992 Windshield Seal Melting/Deteriorating

Vehicles Affected

Models	Model Year	Model Type	VIN Range	Vehicle-Specific Equipment
911	As of 2020 up to 2023	992	N/A	All except VW4 Lightweight Glass

Figure 1

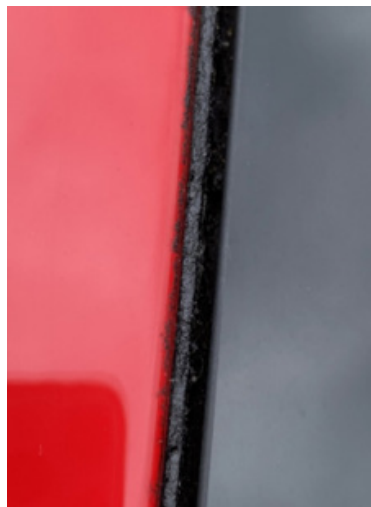
The customer complains of the windshield seal melting or deteriorating.

The observed condition can be the result of a material incompatibility between the windshield seal material and the adhesive used for fixing the windshield. When these two substances come into contact, a chemical reaction occurs, forming a melted and sticky appearance of the windshield seal. It is important to note that extended exposure to sunlight can make this condition worse.

The service recommendation is to replace the **affected** windshield(s) with one of the following new part numbers:

Part	Part Number
Front Windshield Glass	992.845.011.AN
Rear Windshield Glass	992.845.047.DY
